Gravesham Borough Council

Air Quality and Nitrogen Deposition Assessment Peer Review – Lower Thames Crossing

June 2023

Figure 2-1 Location of Greatest Change in NO₂ Concentrations

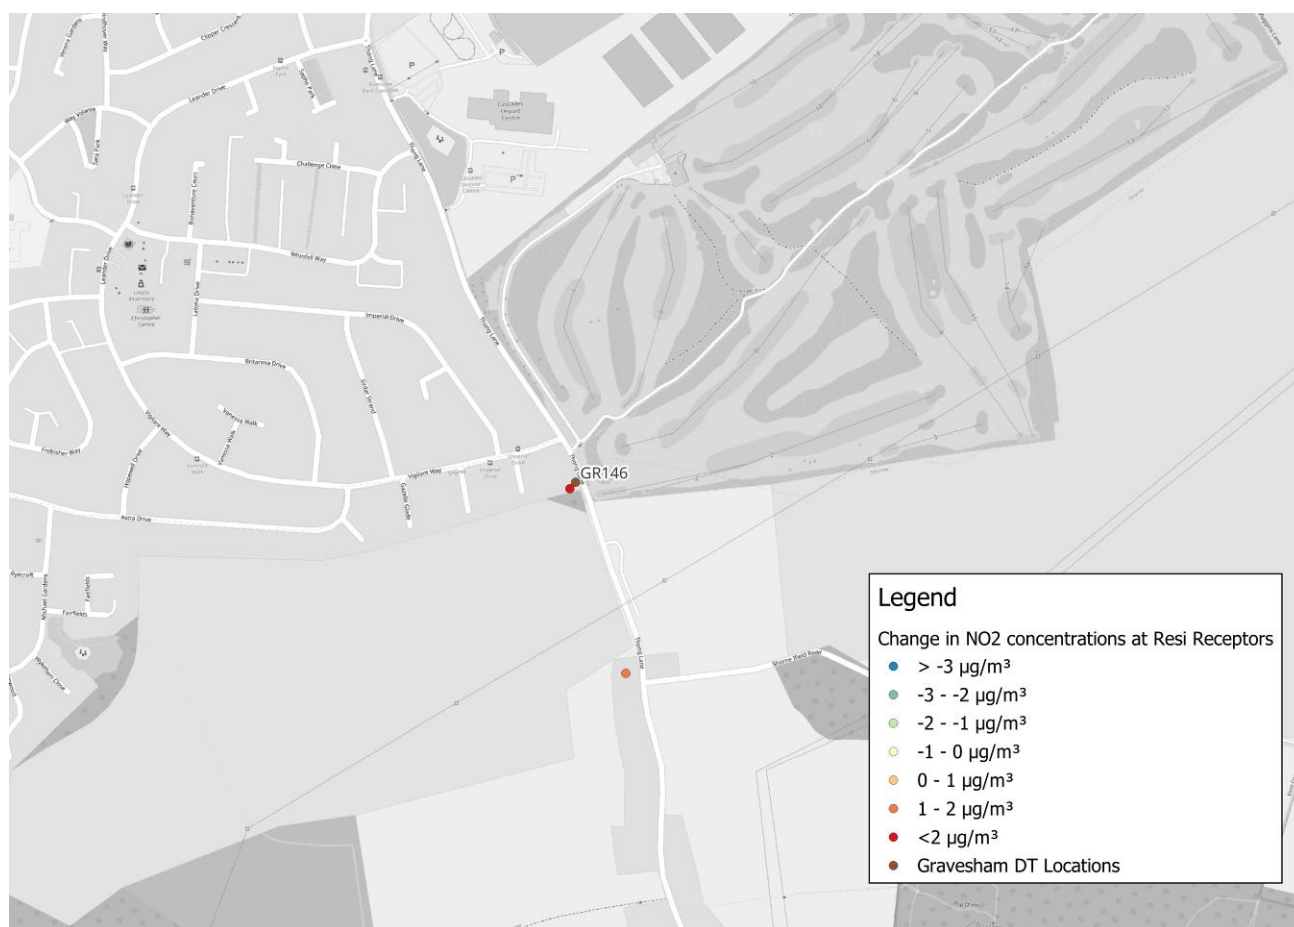
The baseline concentration is in good agreement. The increase is significant, but the concentration remains below the Air Quality objective of 40µg/m³. It is therefore not considered that any further work or mitigation is needed at this location.

Figure 3-1 Proposed Mitigation for Affected Habitats within Gravesham

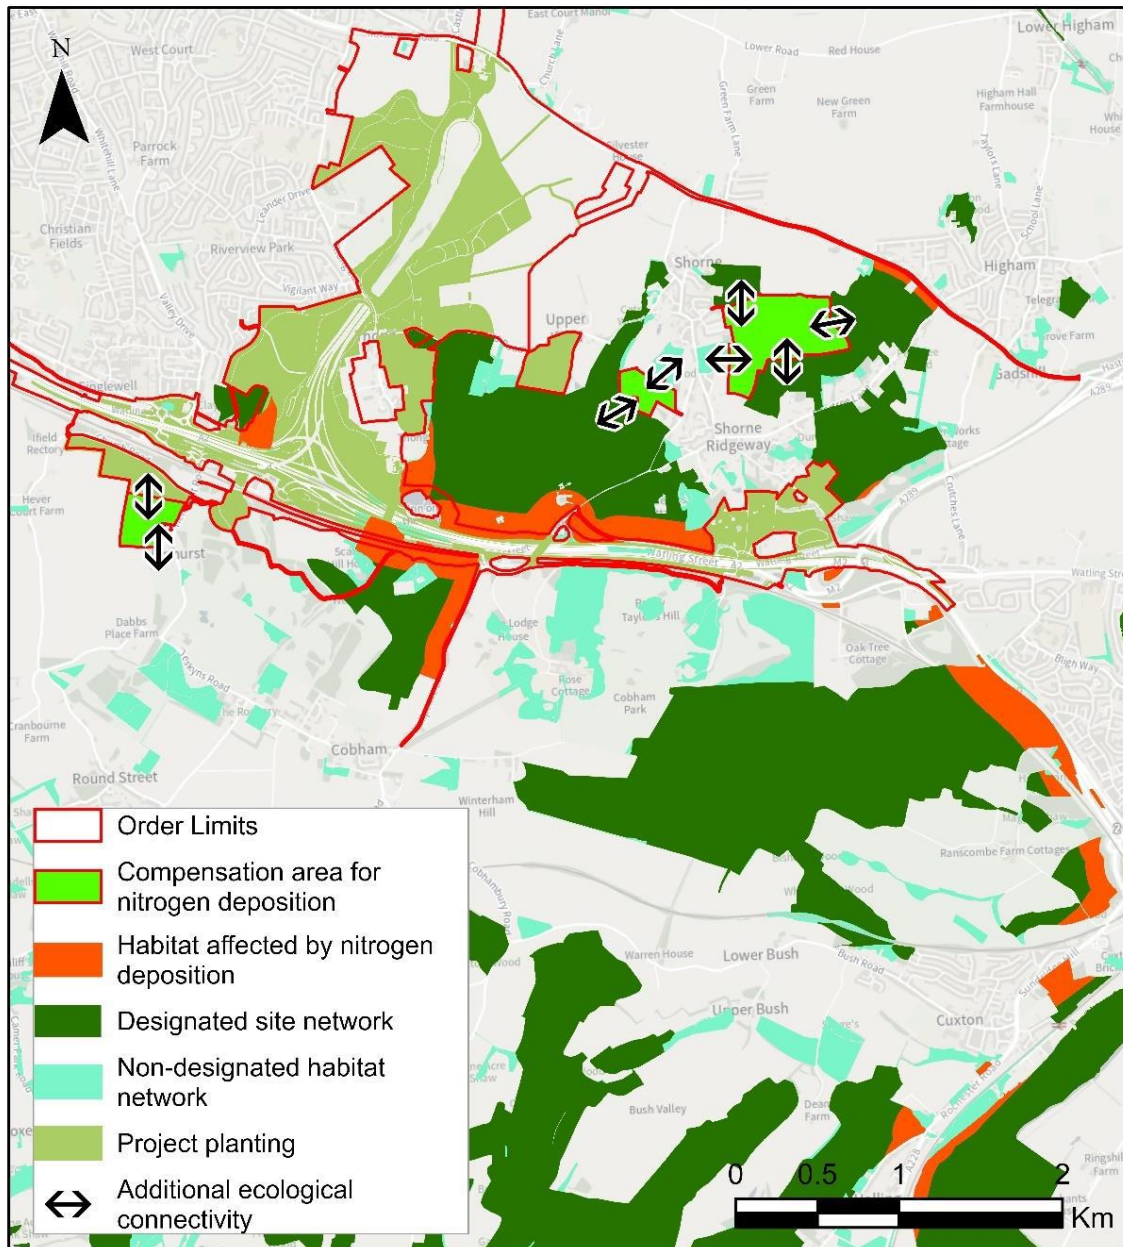
There was consideration of speed limit changes at the area around the Ashenbank Woods SSSI but this was not taken further forward for assessment. The applicant also states in 5.8.2 of 6.1 Environmental Statement Chapter 5 *“The Project does not require mitigation for operational air quality effects for human health or compliance with Limit Values. Whilst there are significant effects on the biodiversity sites and speed enforcement on the M2 has been assessed, it is not appropriate to undertake nitrogen deposition monitoring. Monitoring will not aid in determining whether the mitigation is effective as there is no ability to monitor conditions with and without the Project. Given that the impacts are as a result of the change in N deposition rather than for example absolute concentrations against AQS objectives, monitoring would only provide information related to the conditions at the time the monitoring was undertaken. In addition, as the speed enforcement would not be time limited, monitoring would not be needed to determine when the measure is removed.”*

Figure 6-1 Suggested Monitoring Locations

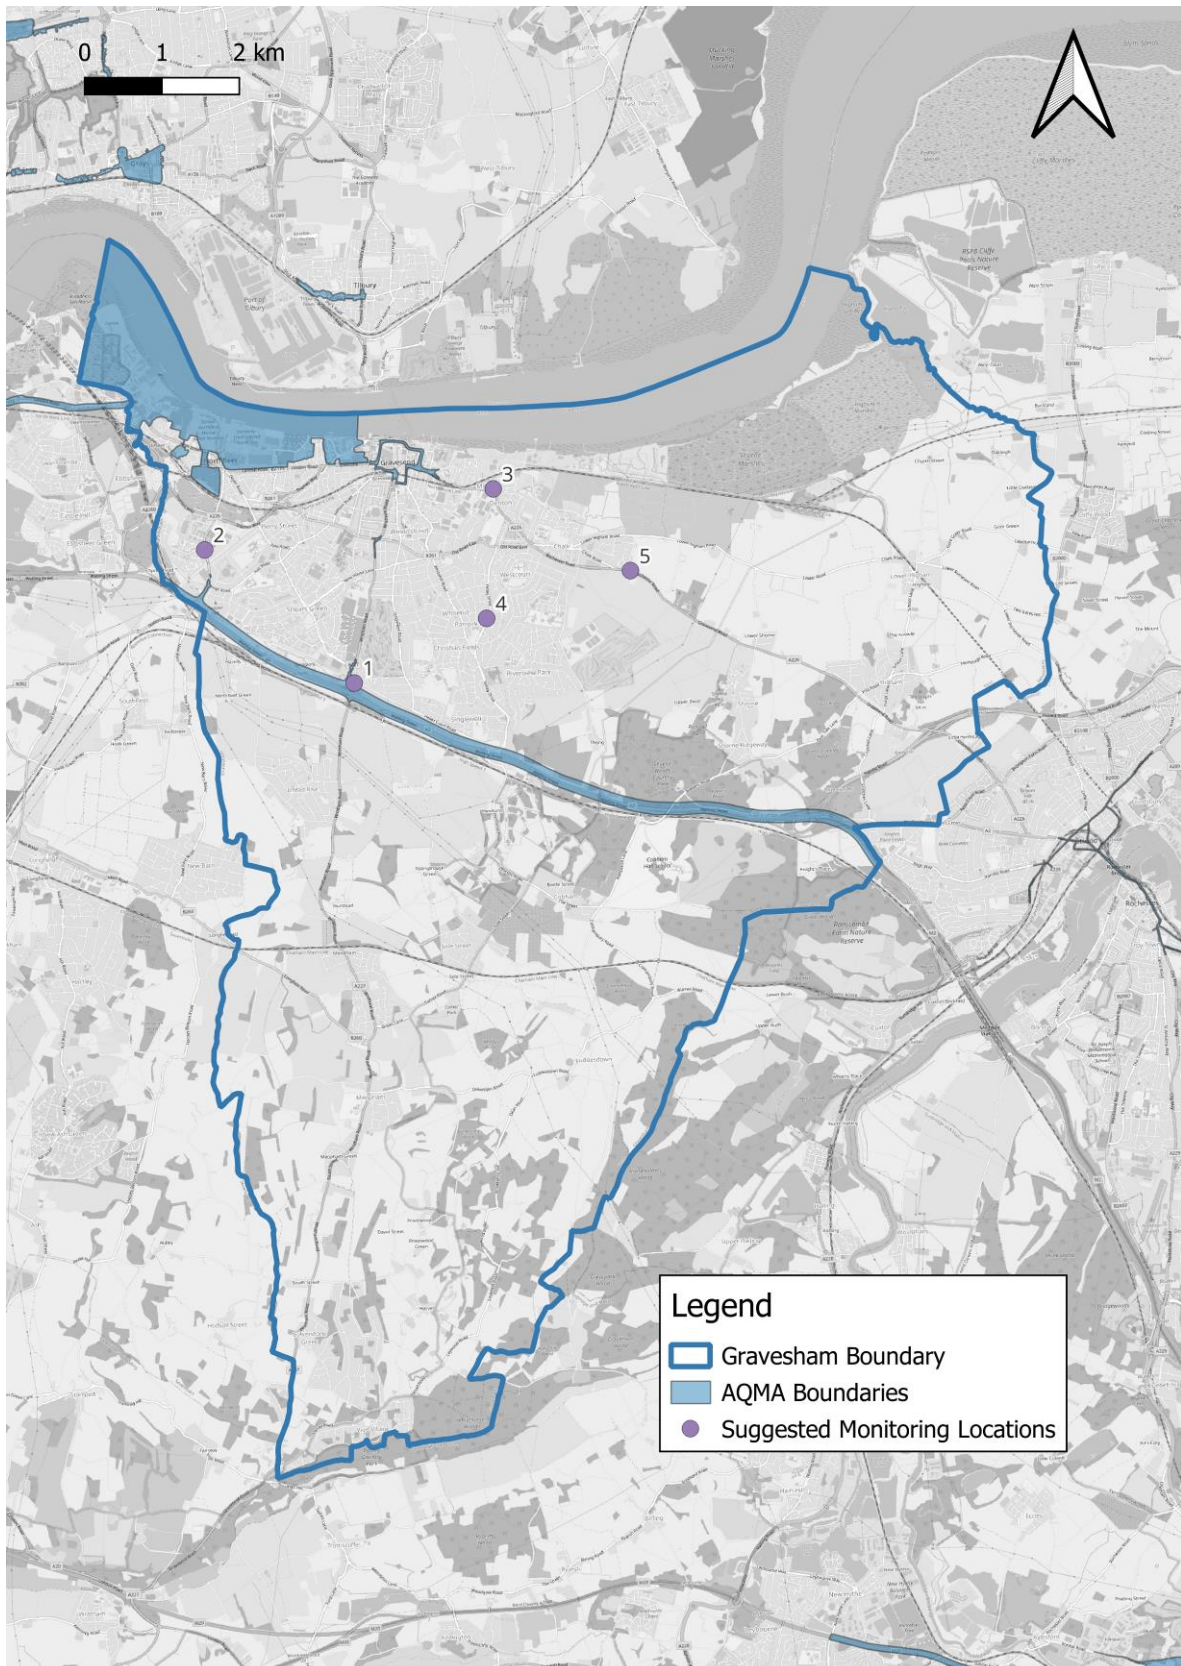
Five potential locations are shown below for including monitoring at locations where there are predicted increases which are greater than 1% of the AQO for NO₂ (i.e. 0.4µg/m³) and where there is not already existing monitoring.

Ideally, automatic monitoring stations would be installed through which live data could be recorded. An alternative would be for NO₂ diffusion tubes to be installed at these locations.
